Register Reference : 91A/1255

Applicant : Sean and Dora Kelly

Development : Rehabilitate service station site to include the
demolition of a derelict unserviced dwelling, the
erection of new canopy over 3 no. pump islands, the
provision for a carwash, the erection of a service
area, and the installation of increased underground

LOCATION : Ballynakelly, Newcastle

GABBLE DETAILS FOR PROTECTION OF EXISTING
ADJOINING DWELLING HOUSE.

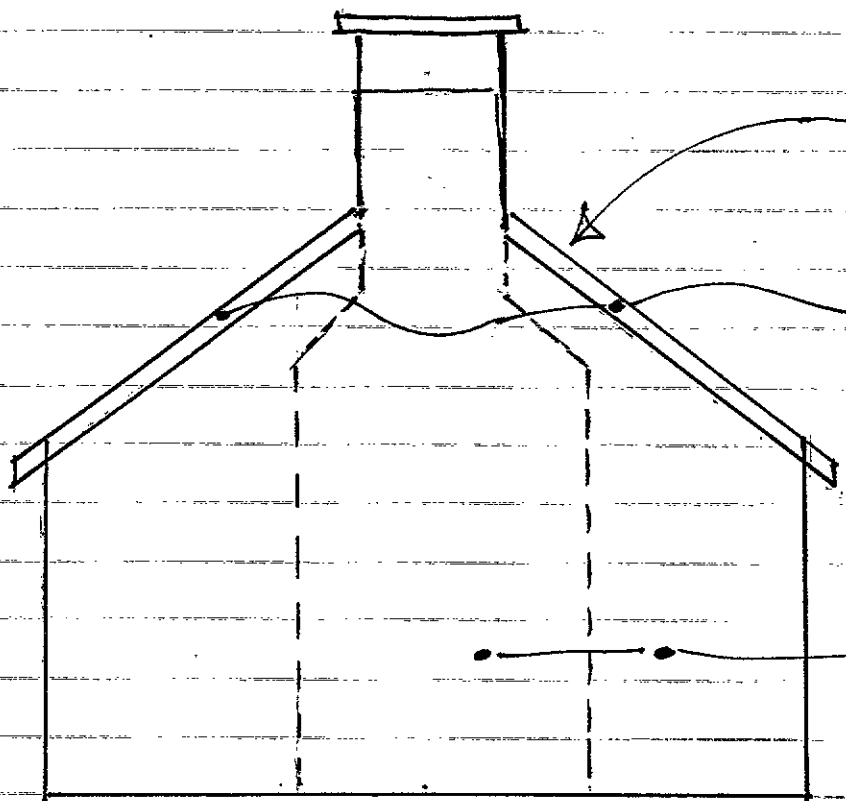
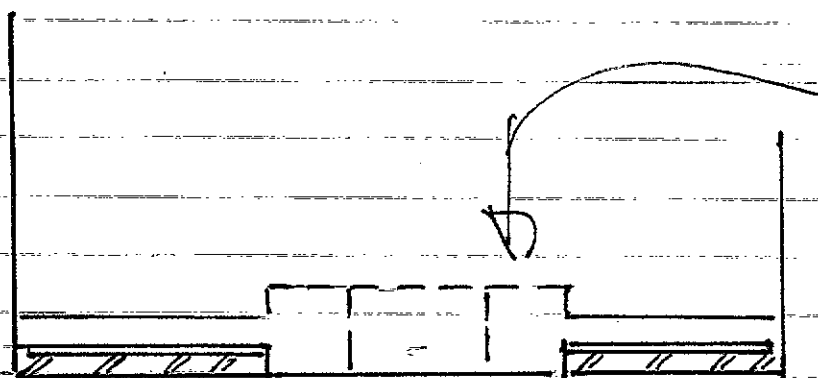
Should permission be granted a condition requiring the exposed gable of the inhabited dwelling to be properly waterproofed would be desirable. Also a landscaping plan, should be submitted, with native tree species to help blend the development into the landscape.

- 0.6 The gable details for the protection of the existing adjoining dwelling house on the LHS middle boundary are as attached. We also enclose a note by Mrs. Dora Kelly concerning the agreement of this adjoining owner to the proposed development.
07. Reference Drawing No.3231. It is not proposed to make any connection to the existing foul sewer. The existing sewer lines are as marked up on Drawing No.3231 A attached.

Scale <i>1/8" = 1'00'</i> Date <i>July 91</i> Drawn Checked <i>M. K. Kane</i>	Drawing No <i>3229.</i>
<i>SEAN + DORA KELLY</i>	<i>TEXACO (S) Ltd.</i>

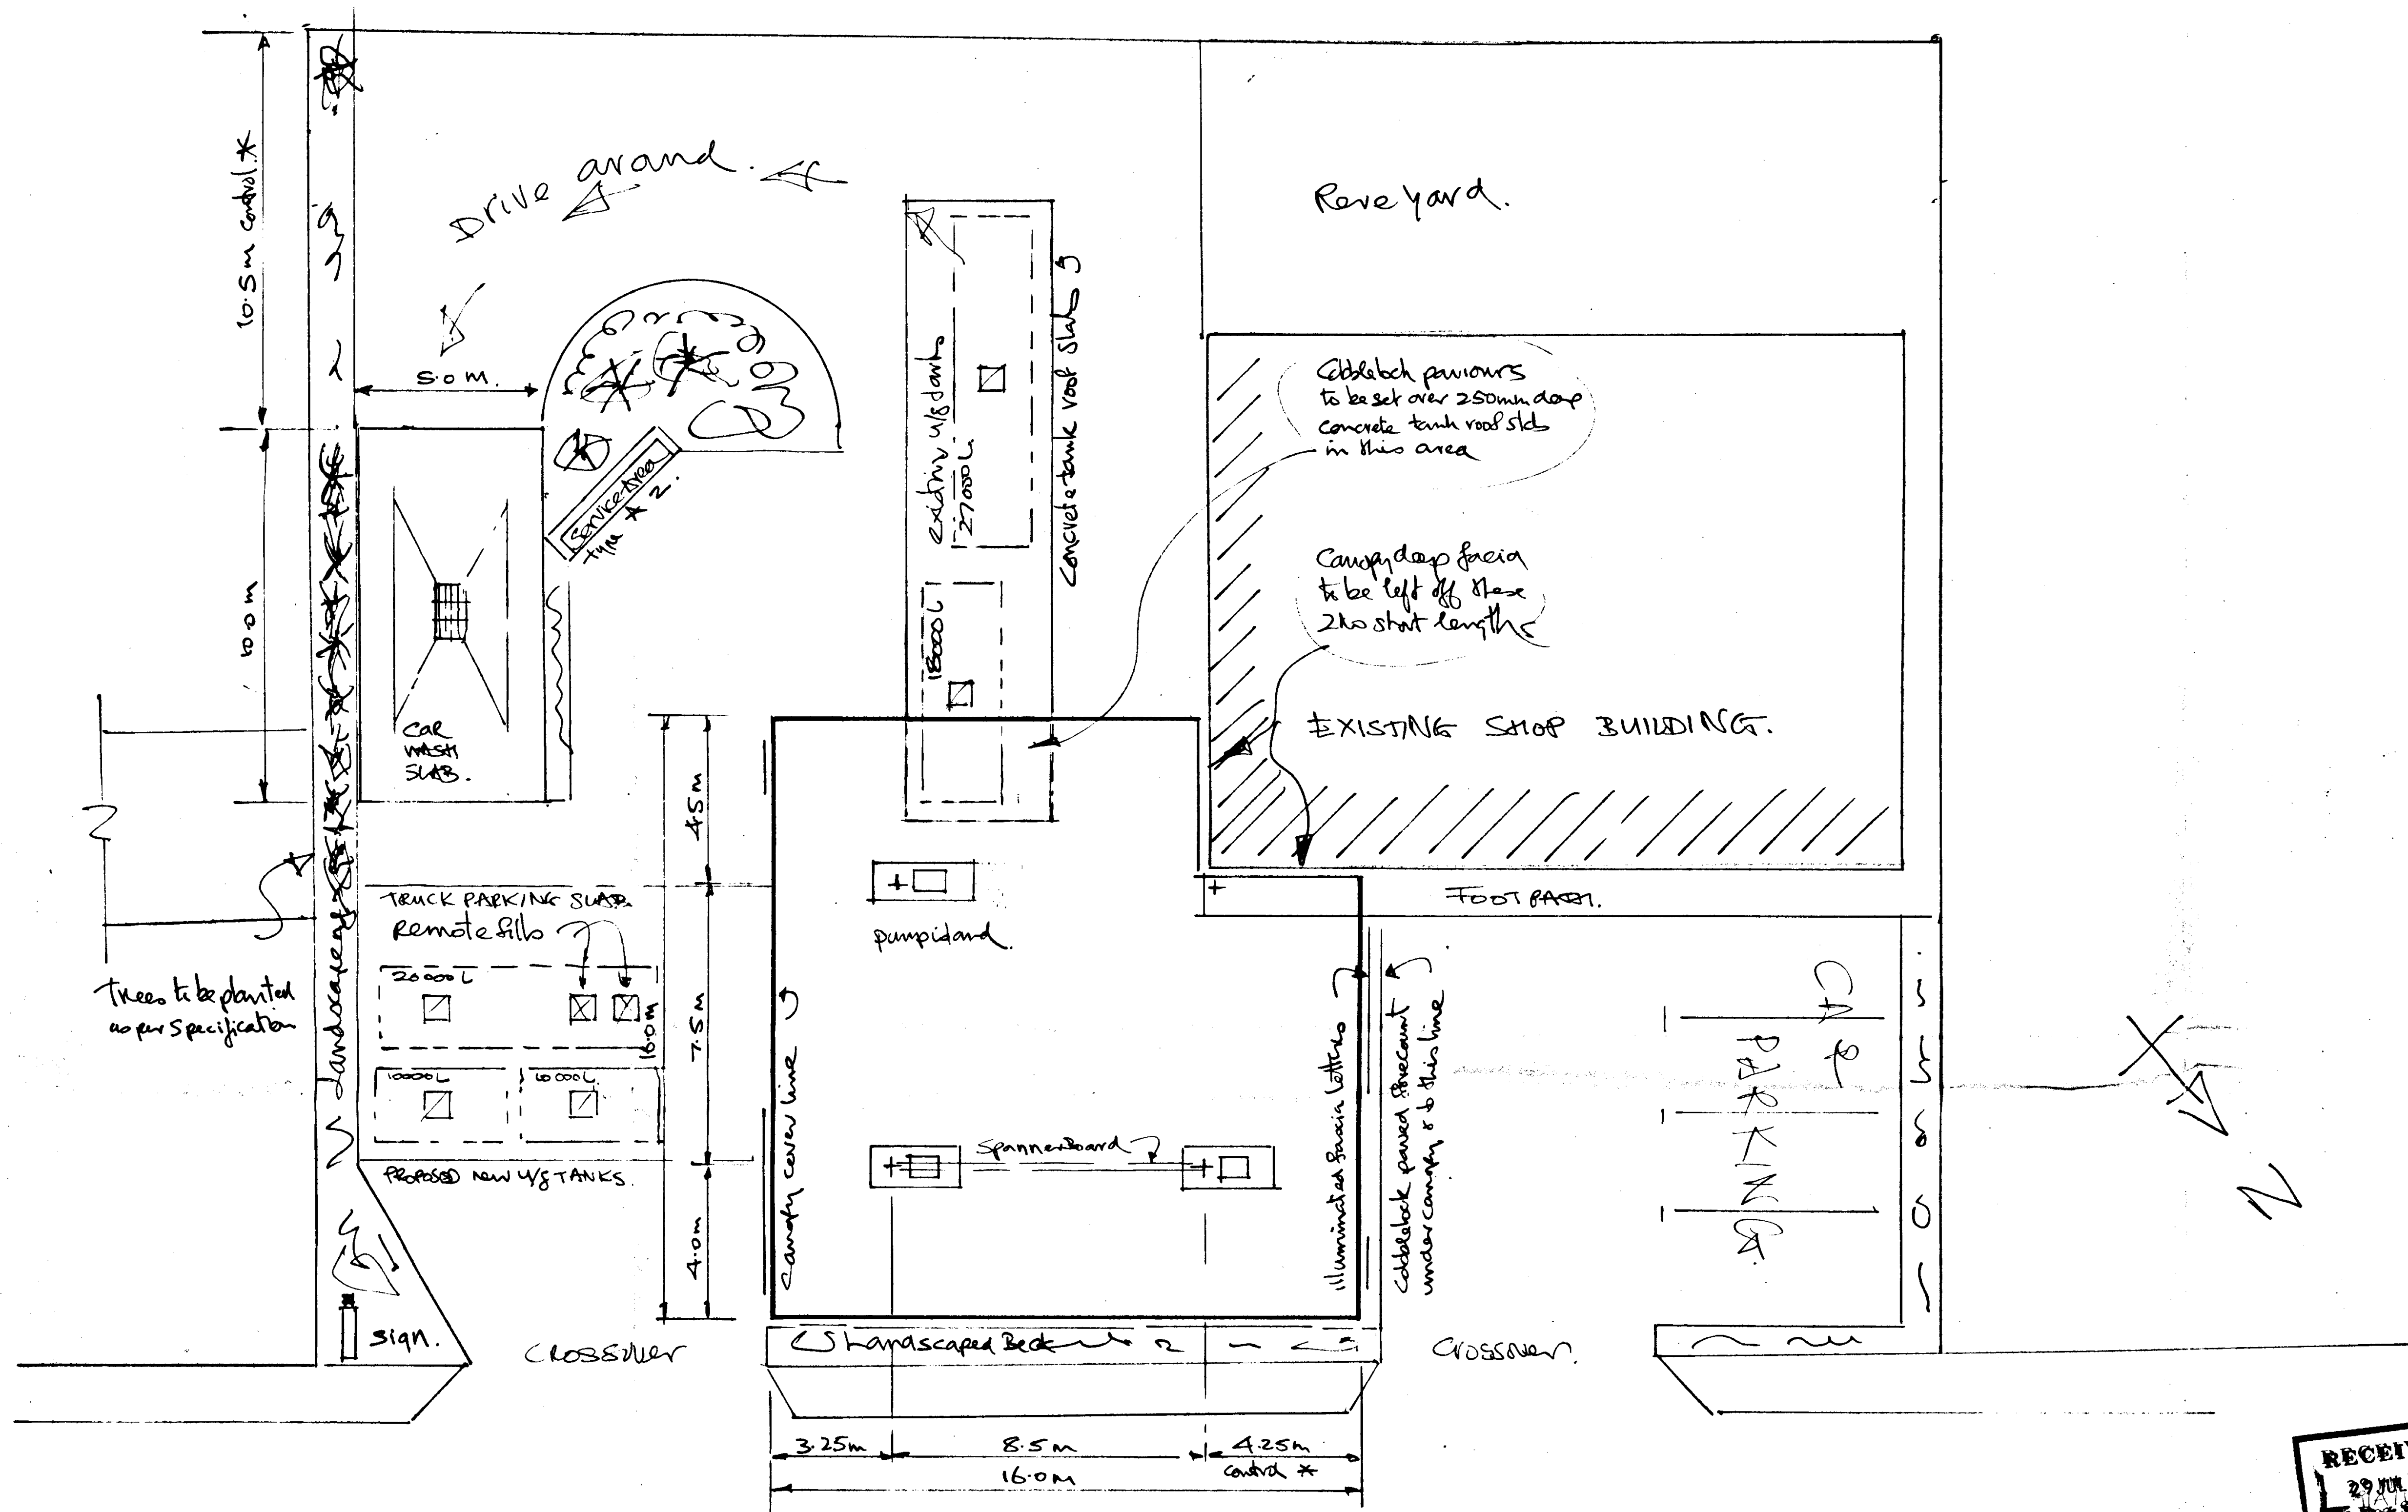
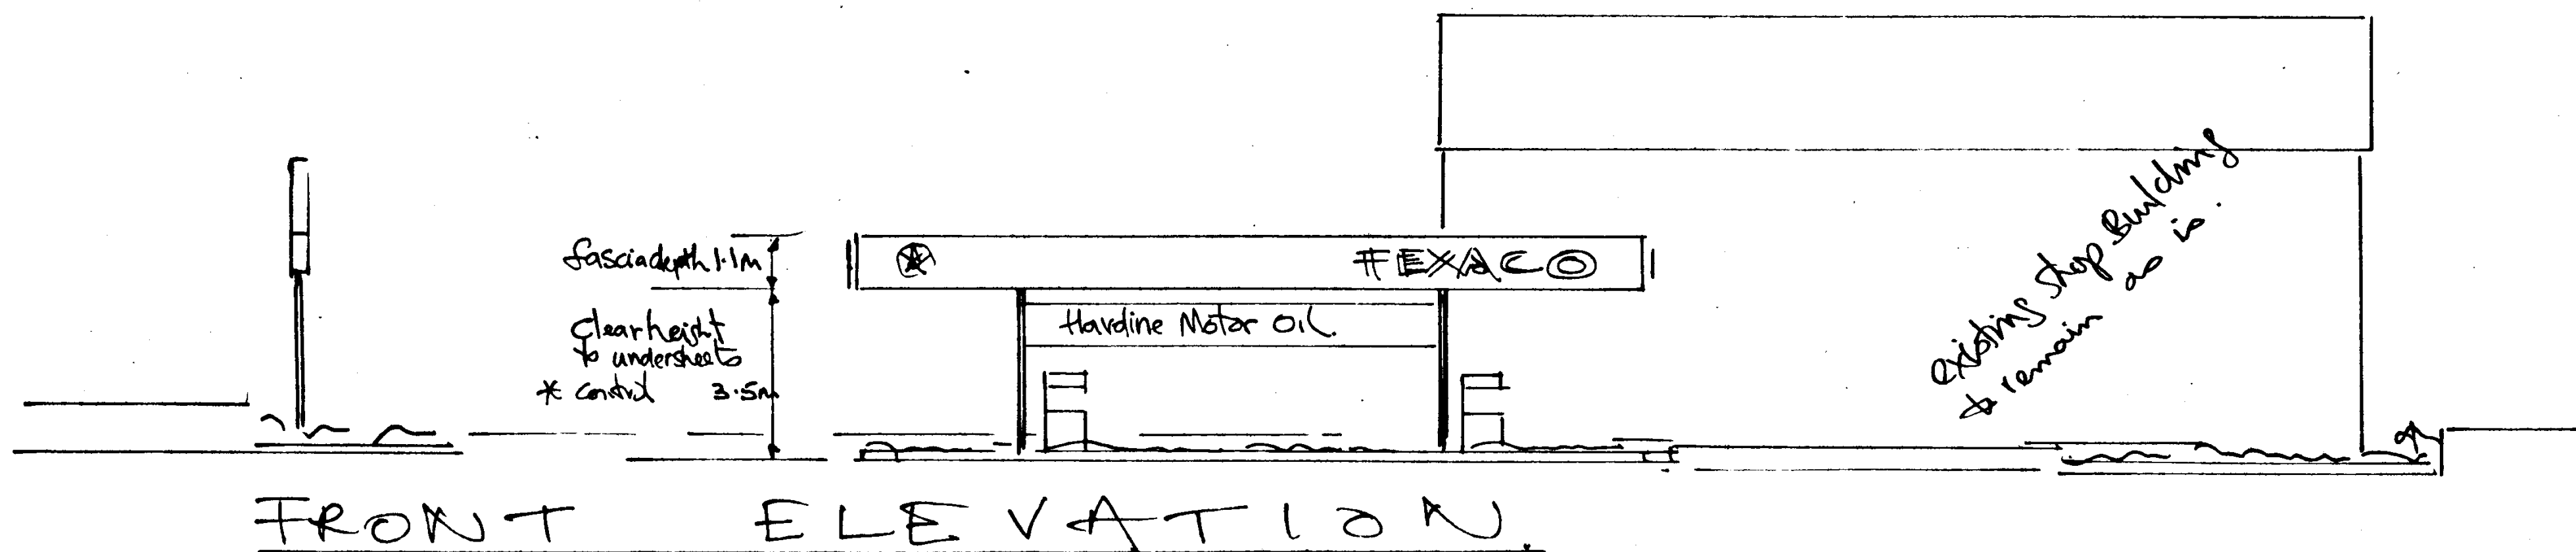
1. Insufficient details of the definition of the proposed front boundary of the site have been provided together with treatment of the area between site boundary and the public carriageway. The applicant is requested to submit these details.
2. Insufficient details have been submitted with regard to boundary treatment of the property with adjoining properties. The applicant is requested to submit these details in order to show that the proposed development will not have an adverse affect on adjoining properties.
3. Insufficient landscaping details have been submitted. The applicant is requested to submit a full landscaping plan together with details of planting times and a maintenance programme.

- 01 Insufficient details of the definition of the proposed front boundary of the site have been provided together with treatment of the area between site boundary and the public carriageway. The applicant is requested to submit these details.
- 02 Insufficient details have been submitted with regard to boundary treatment of the property with adjoining properties. The applicant is requested to submit these details in order to show that the proposed development will not have an adverse affect on adjoining properties.

01. Reference Drawing No.3229. It is proposed to delineate the front boundary with a landscaped bed approximately 1.0M wide bounded by 225mm x 125mm precast concrete kerbs set on edge on sand and cement bedding on 150mm concrete bases to lines shown along the perimeter on these beds. Regarding the treatment of the area between the site boundary and the public carriageway, it is proposed to construct a footpath across the site frontage in line with the existing footpath on either side of the site. It is proposed to construct this footpath in concrete to match the existing footpath on LHS. It is proposed to join the footpath to the crossover surface by a radius line with a bullnosed finished edge. It is proposed to saw cut the line joining the outside of the proposed footpath at the crossover along the side of the carriageway and to extend the forecourt tarmac to marry smoothly to this saw cut edge. It is proposed to carry out all this work to Dublin County Council standards and as discussed with Roads Engineer, Mr. Tim Brick.

02. Reference Drawing No.3229. It is not proposed to make any alterations to the boundaries of the property with adjoining properties. The property on the RHS is bounded by a low wall (approximate height 0.8M). It is proposed to set a landscaped bed in front of this to contain a car parking lot for 4 No. cars and to prevent cars from rolling against the wall. On the LHS the property is bounded to the rear by a high wall (approximate height 2.0M). It is proposed to set a landscaped bed in front of this to contain the rear forecourt area.

Reference Drawing No.3229. The elevation shows the clear height to undersheets on the canopy cover to be 3.5M. Large vehicles not exceeding this height could negotiate a line through the site between the proposed lines of the rear pump island and the front pump islands. Trucks and large vehicles requiring head room greater than 3.5M will not be able to cross under the proposed canopy. It will not therefore be possible to cater for such vehicles.

PROPOSED DRAINAGE LAYOUT  
KELLY'S Service Station, Newcastlle  
Co. DUBLIN

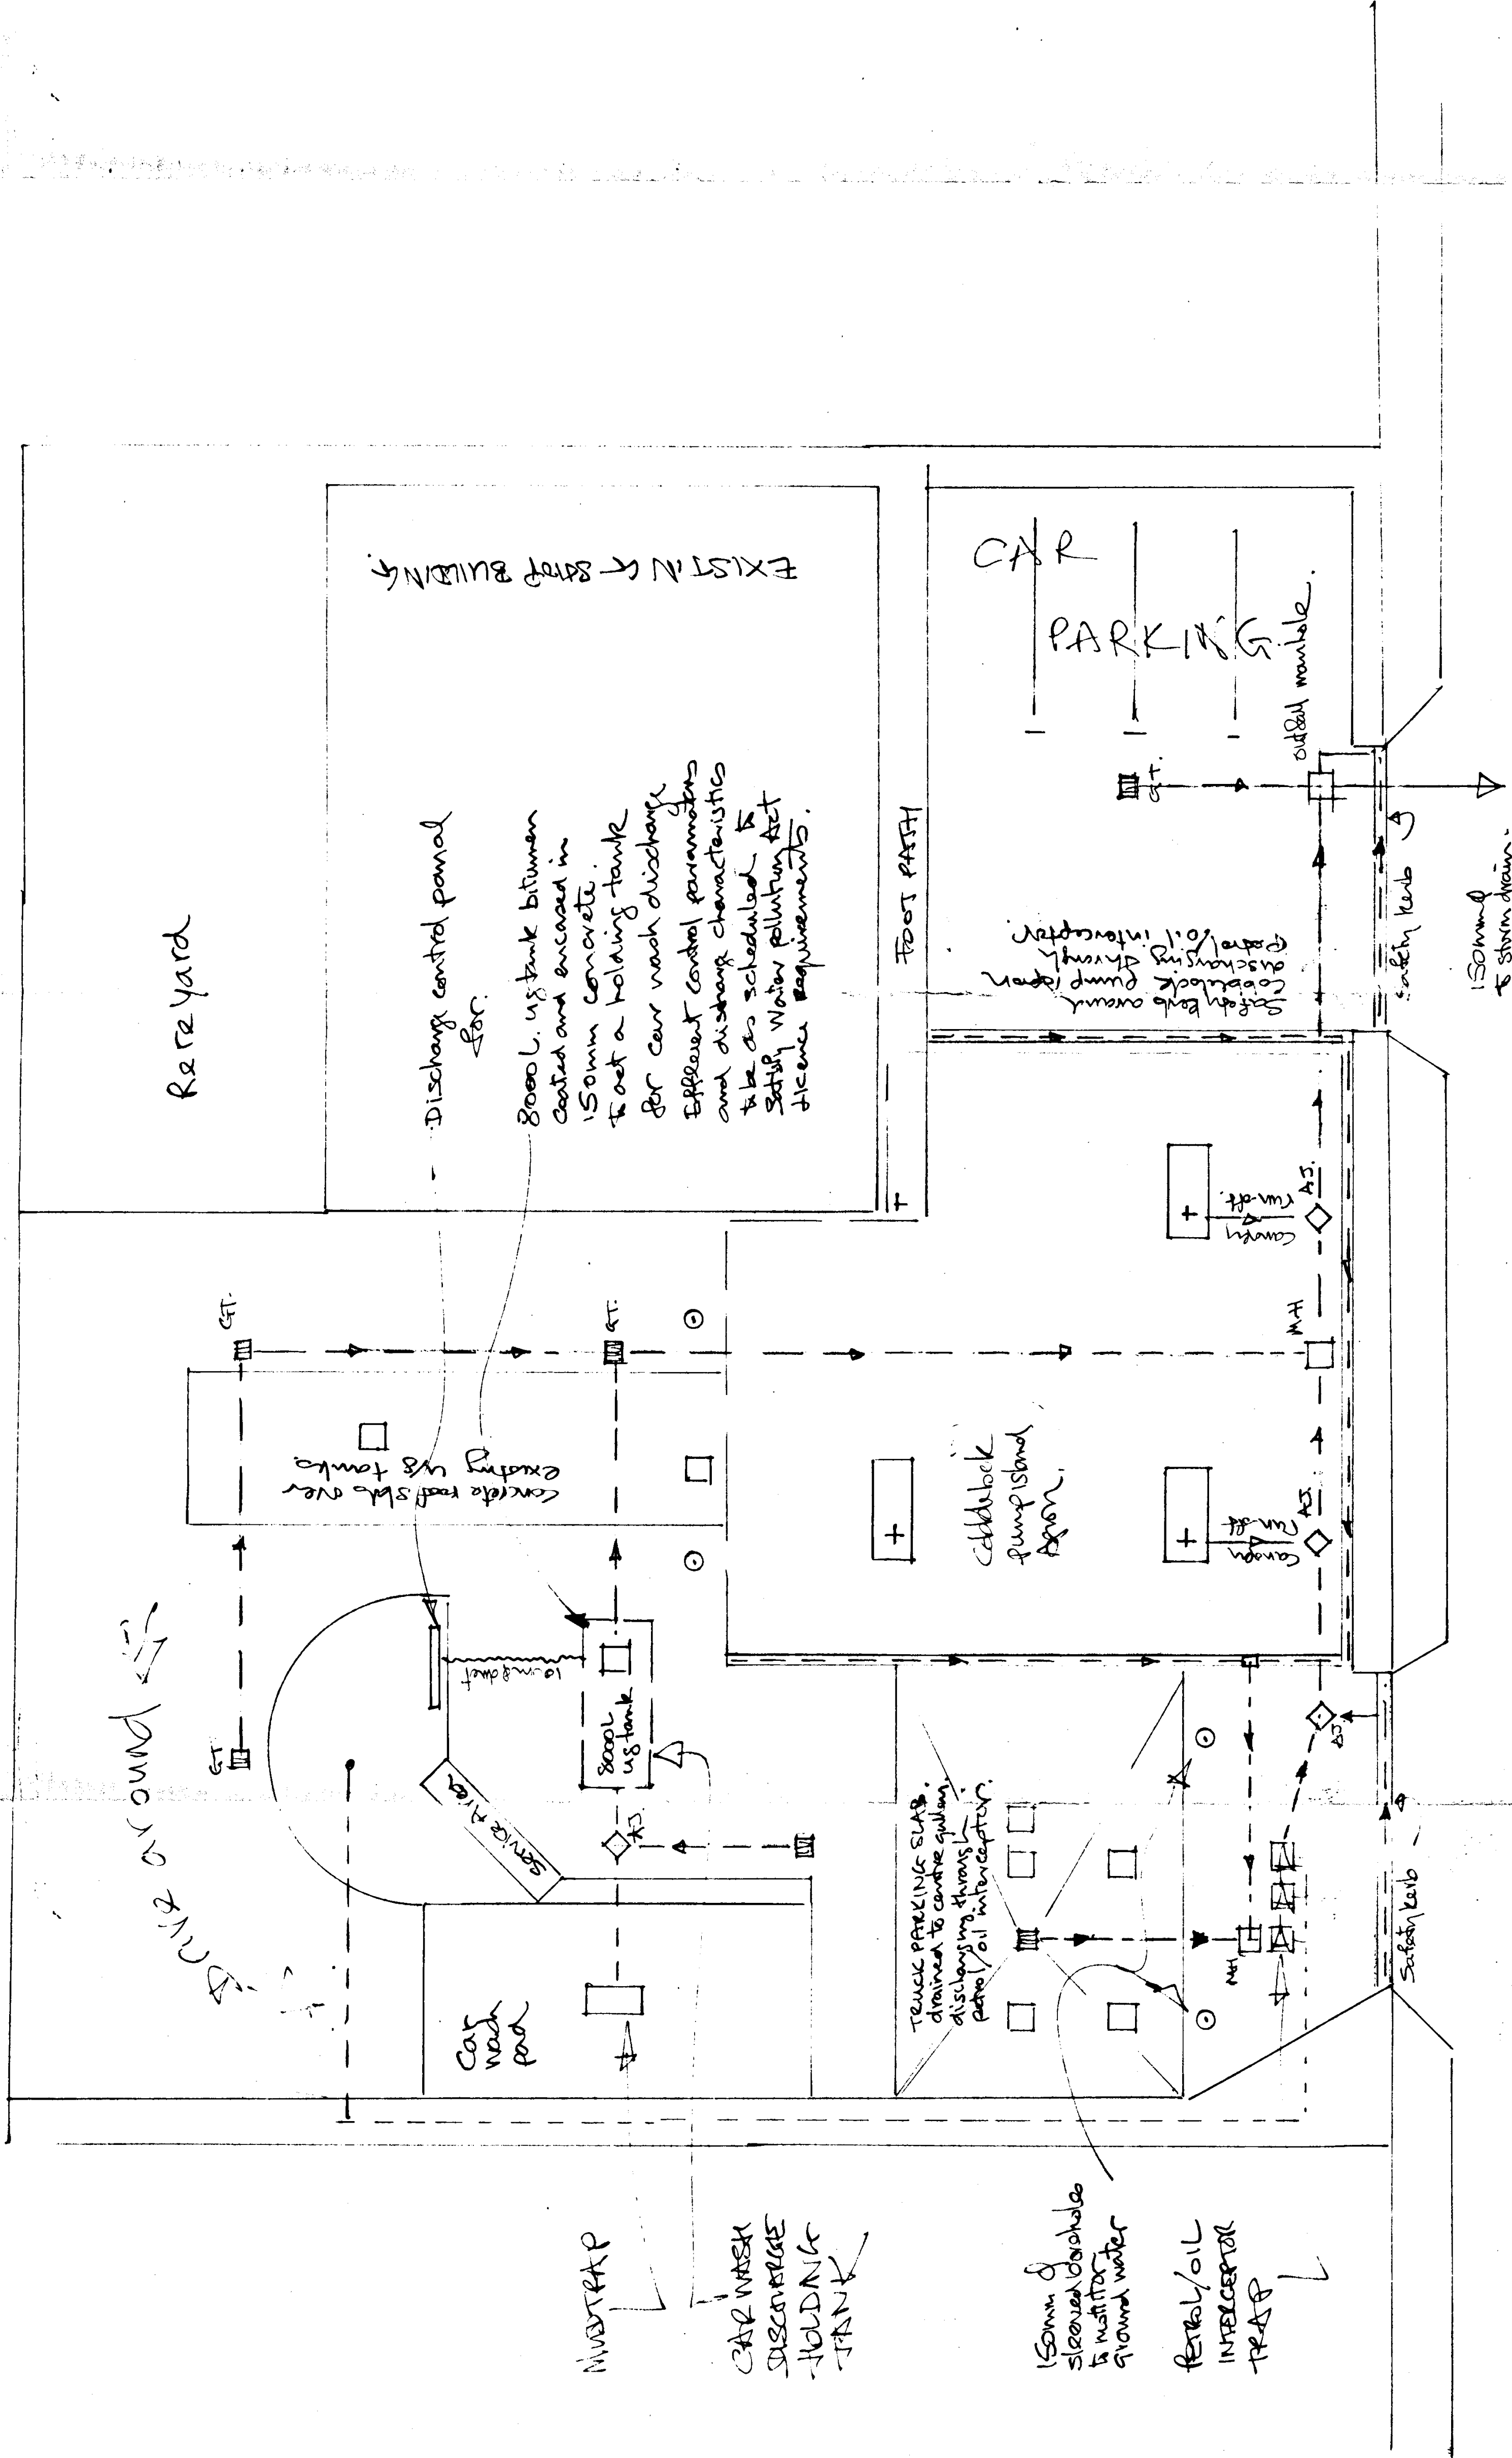
- 1) Drainage arrangements for foul and surface water systems to be indicated on plan.
- 2) Ventilation of shop, sanitary accommodation and adjoining lobby to be indicated.
- 3) Sanitary accommodation not indicated on plan.

08. Reference Drawing Nos. 3229, 3230 and 3231. Following discussion with Mr. Barry Morris, Sanitary Services Engineer, it is proposed to delete the car wash element of this proposal including all drainage provisions associated with this element. At his suggestion we will take this matter up with the Water Pollution Authority and will seek guidance on the obtaining of a Water Pollution Act Licence following which we may consider making a further separate planning application for a car wash facility.

Regarding the problem of trapping waste petroleum products we would propose to install a Visqueen Membrane in the sand bed as per the attached detail. We would not propose to install any system of drains through this sand layer as we would consider this might present a greater risk of fire or explosion than might normally be associated with an accidental spillage on the forecourt area. The proposed connection details to the public surface water drains are as attached.
